SIEMENS

July 30, 1996

License No. SNM-1227

Docket No. 70-1257

FIGURE II-10.27b

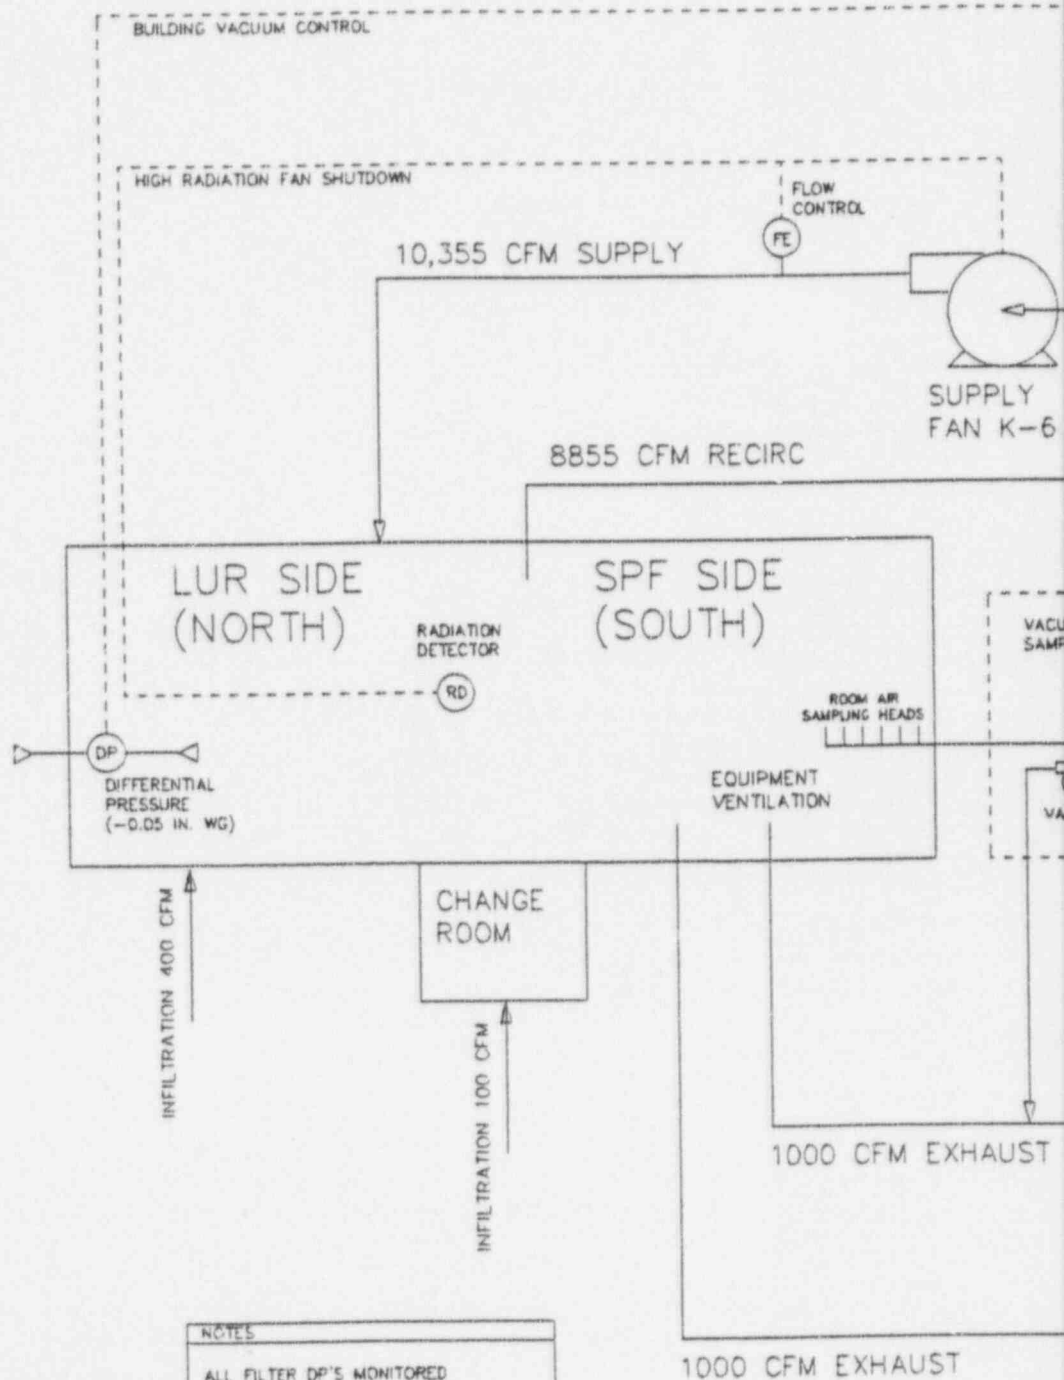
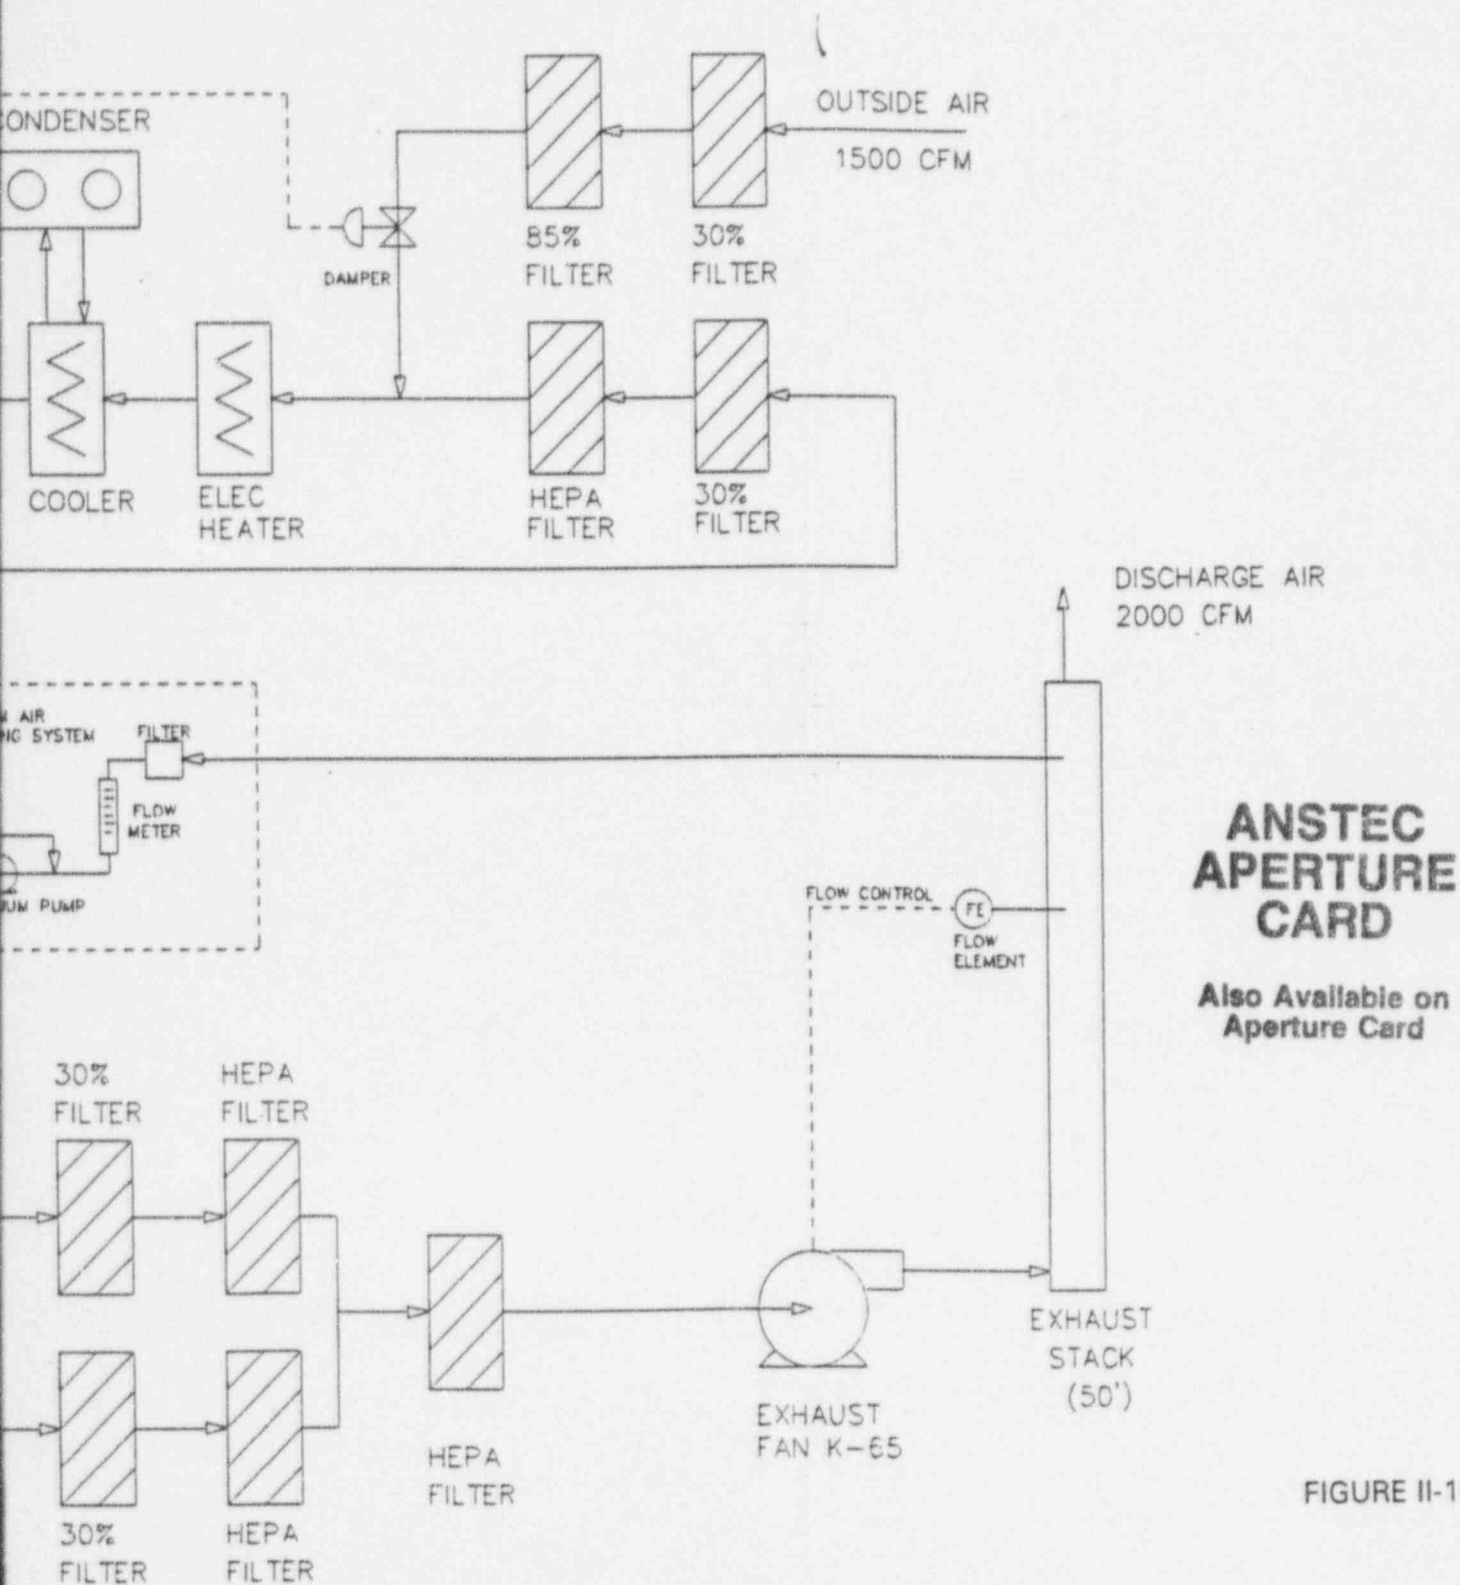
As described in the referenced letter, the HVAC system is sized to accommodate both the LUR building and the SPF addition. The significant change to the HVAC system from that described previously is the provision for recirculating facility air.

The general features of the LUR/SPF HVAC system include a combination of a once-through airflow and recirculation supply system (K64) and a double HEPA filtered exhaust system (K65). A simplified schematic diagram of the HVAC system is shown in Figure II-10.27b.

The K64 air supply and recirculation system supplies approximately 1500 ft³/min. of outside air and also recirculates approximately 8800 ft³/min. of building air. Recirculated air is passed through a roughing filter and a single HEPA filter with an installed efficiency of 99.95% for 0.8 micron DOS cold-generated aerosol. Provision is made in the K64 recirculation system for continuous alpha radiation monitoring of recirculated air upstream of the HEPA filter bank. The alpha air monitor is set to alarm and annunciate when alpha activity exceeds 8 MPC-hr.
